Sherrill Subdivision Sketch Plan

PART 1: PROJECT SUMMARY

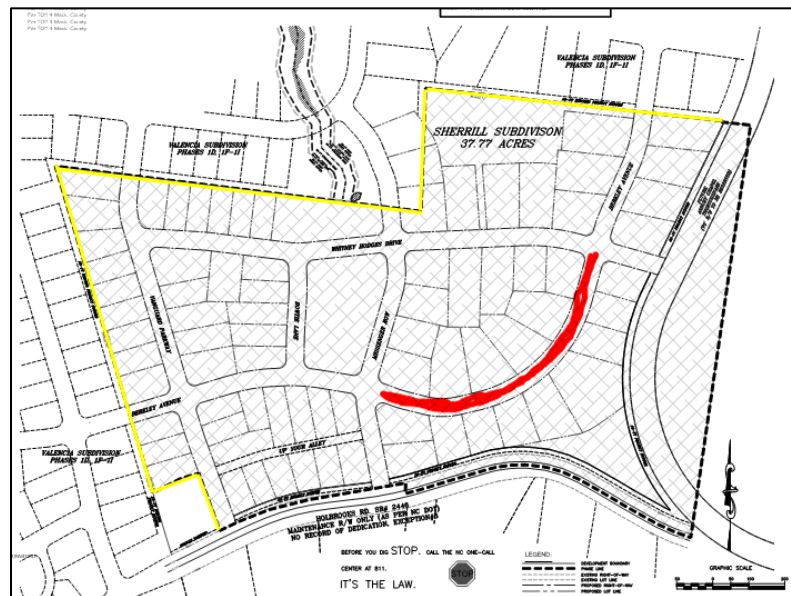
6. Two street connections on to Holbrooks Road are being proposed, four existing connections to Valencia Subdivision are being provided, and a proposed stub to the future Asbury Chapel Thoroughfare. 70' dedication of right of way for the future Asbury Chapel Thoroughfare is proposed, along with dedicated land to allow for Holbrooks to realign. Block lengths are being met, except on Berkley Avenue from Messenger Row to Whitney Hodges Drive (895 ft.). Staff is in support of the block length wavier due to the curvature of the proposed road (reference the red highlighted block within the plan below).

7. Per Article 7.5.3 (foot note 4), where connectivity between subdivisions is appropriate for high quality neighborhood design, the Town Board may reduce or waive the required buffer yard. Staff is in favor of removal of the buffer yard. Due to topography within the adjacent subdivision and the proposed subdivision grading will need to occur to handle storm water efficiently. Sherrill Subdivision will operate as a phase of Valencia (reference the yellow highlighted boundary within the plan below).

Location of
proposed
development

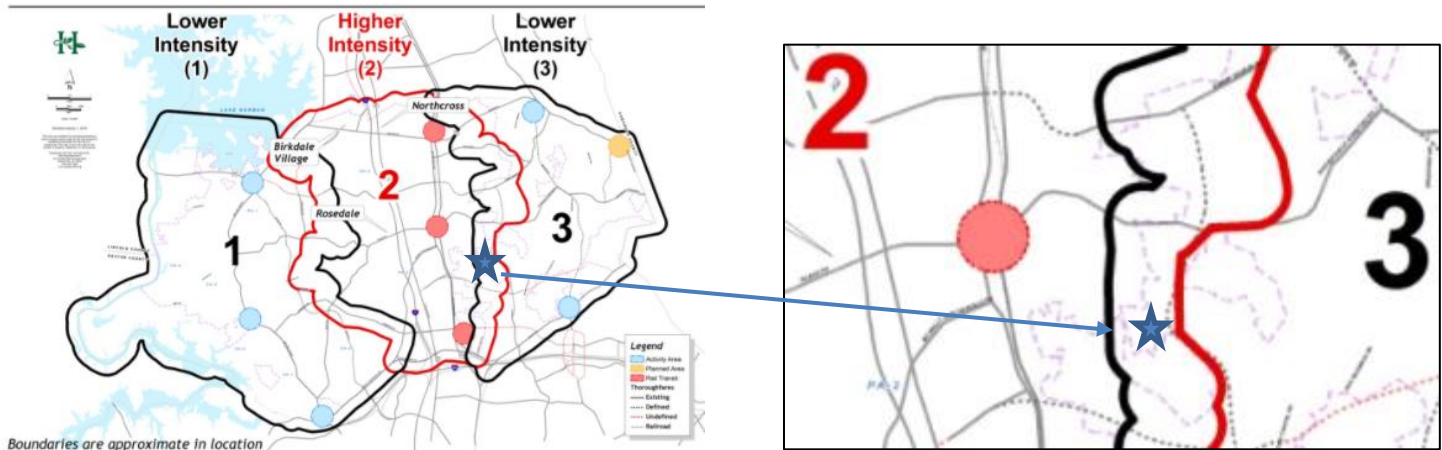
- Extend utilities to open up new neighborhood development along Holbrooks Road.
Comment – The developer will be tying on to public sewer and water. The water line will be extend to Holbrooks Road aiding development.

- New street connections to improve town-wide access in East Huntersville.
Comment – Dedication of the future Asbury Chapel Thoroughfare is required. This will allow construction of a north/south transportation corridor to help disperse traffic. Connections through subdivision streets from Holbrooks to Huntersville Concord will allow residents to travel through the neighborhood streets without having to drive on primary roads.
